PRELIMINARY PLAT AMENDMENT STAFF REPORT WOODS AT VENICE

19-33PP

REQUEST: Preliminary plat amendment petition to request modification of the landscape plan that was approved with the original subdivision for the Woods at Venice, now known as Venice Woodlands.

vs

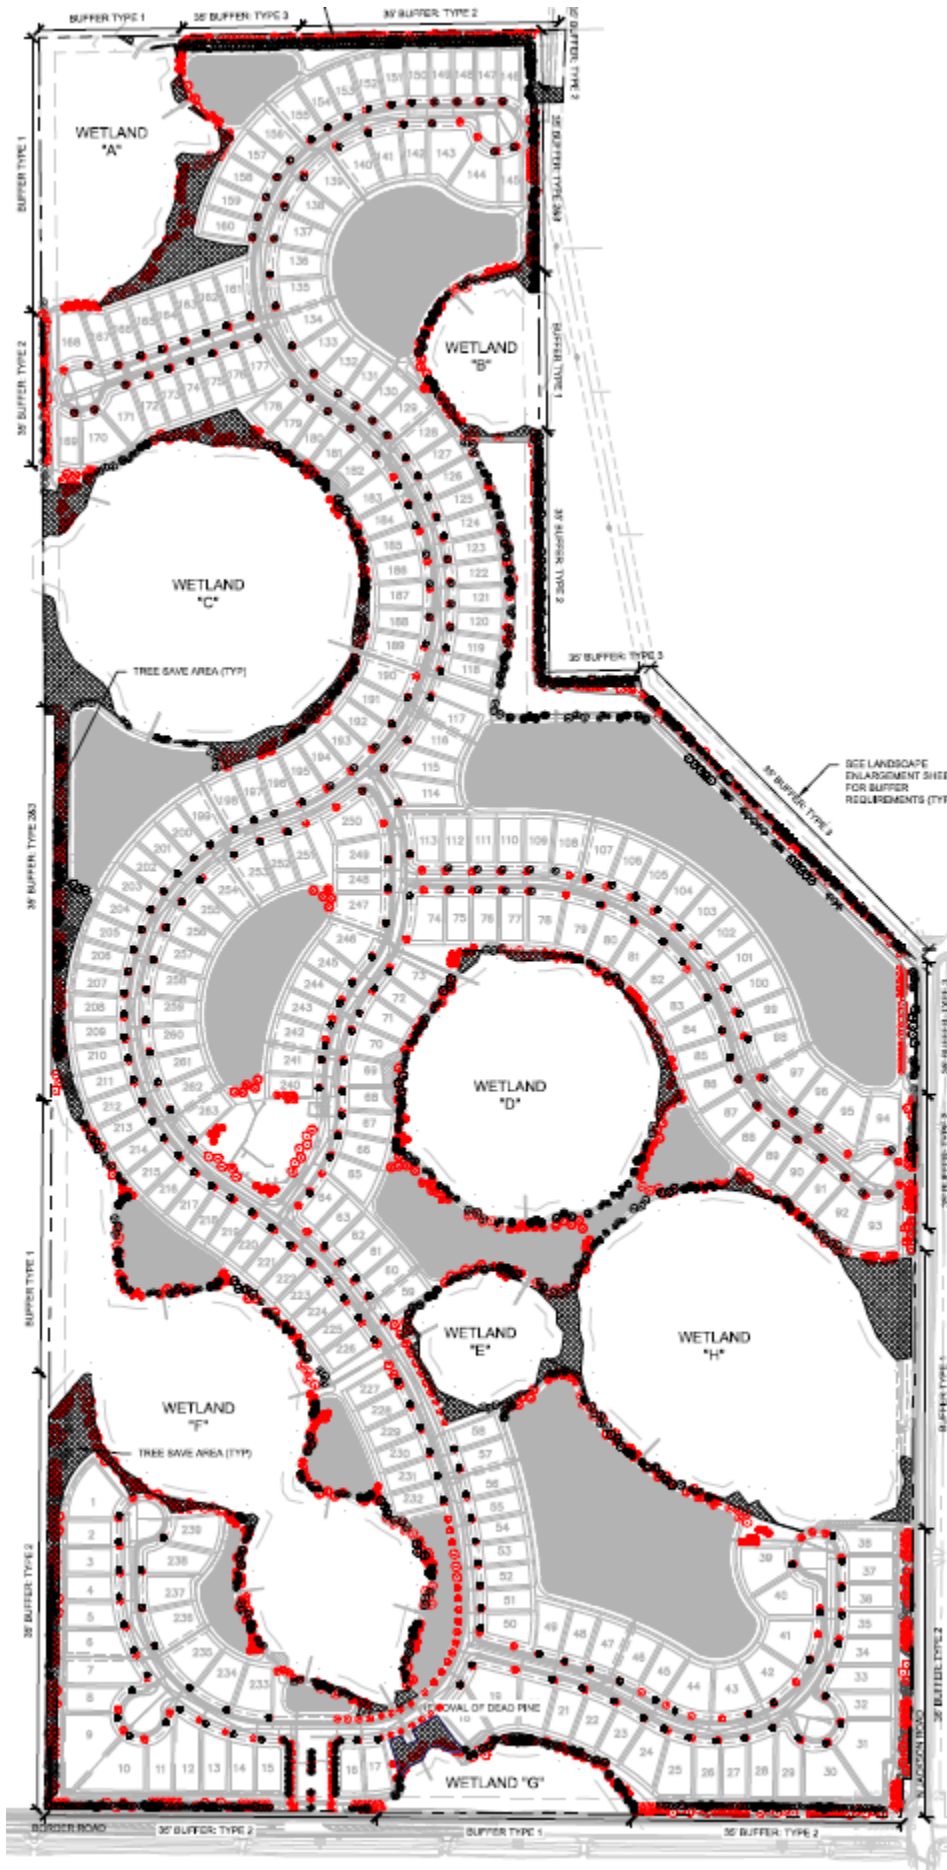
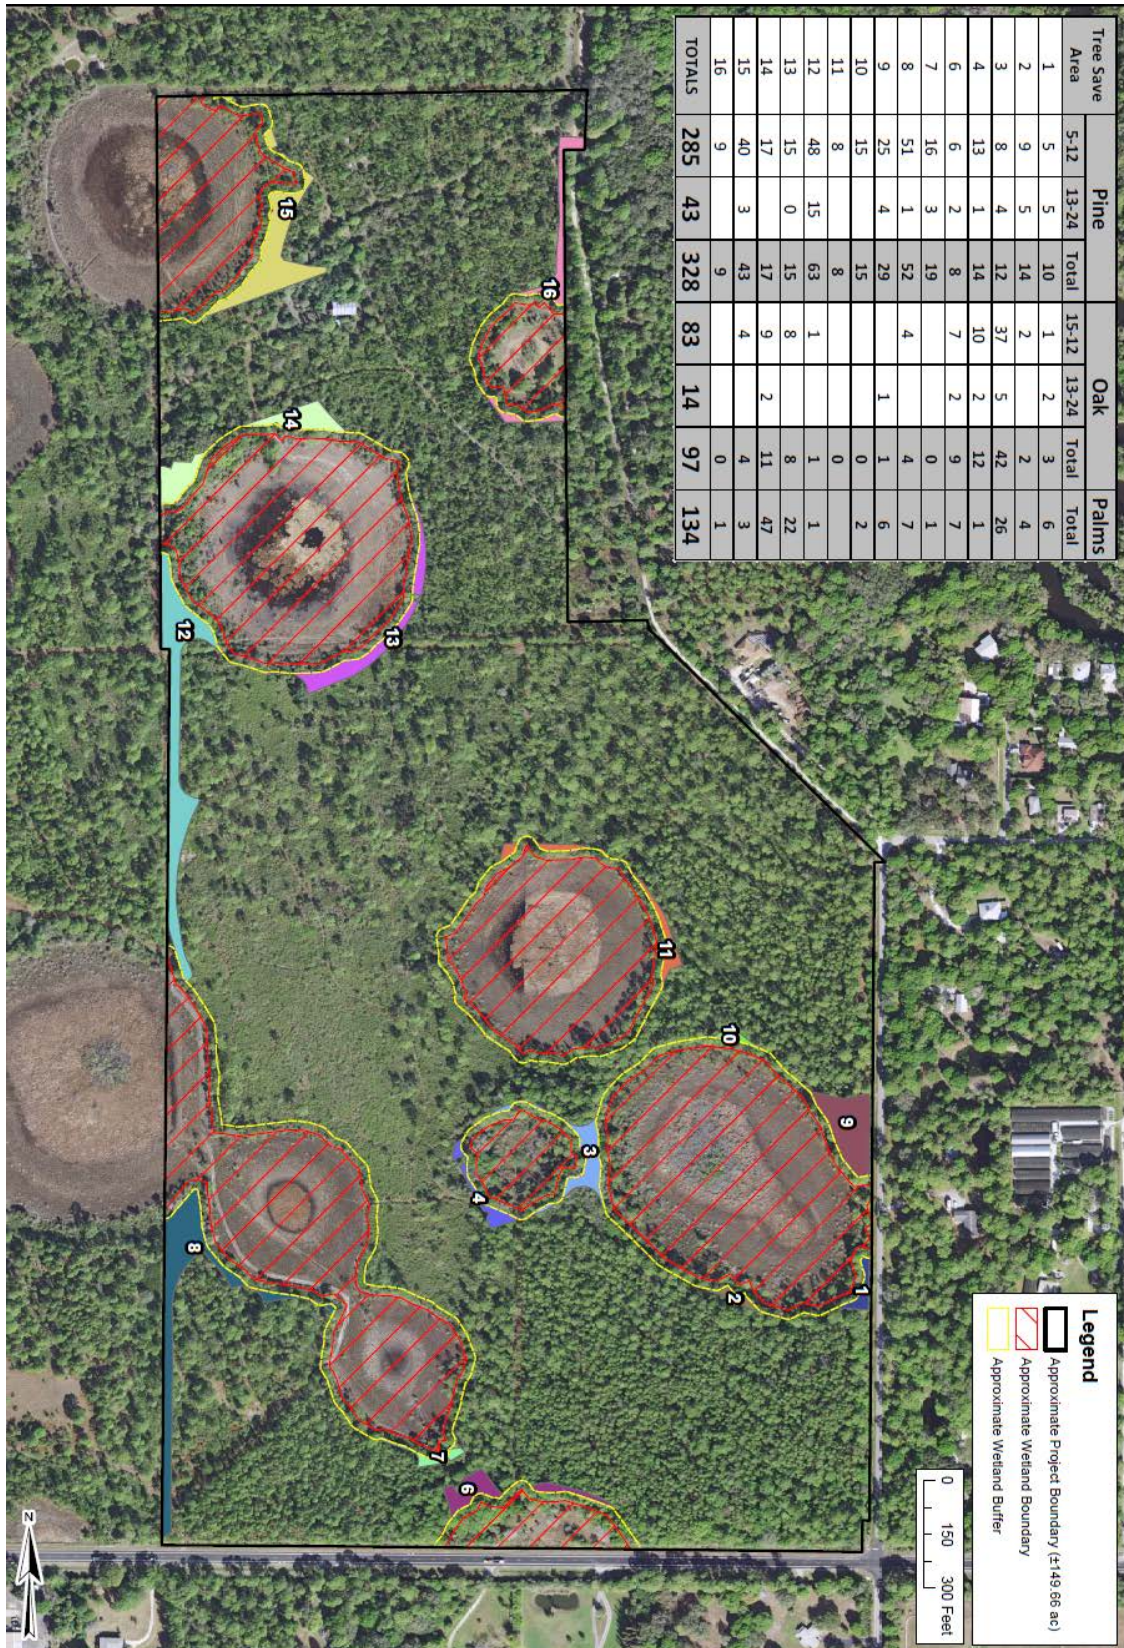
The proposed plan also identifies areas to be planted interior to the development that will now be relocated to the perimeter buffer areas. Relocation of these planting areas will provide for a more significant buffer to achieve the required 80% opacity. There is a graphic depiction on page 5 of this report of the approved vs. proposed landscape plans that was also included in the agenda packet.
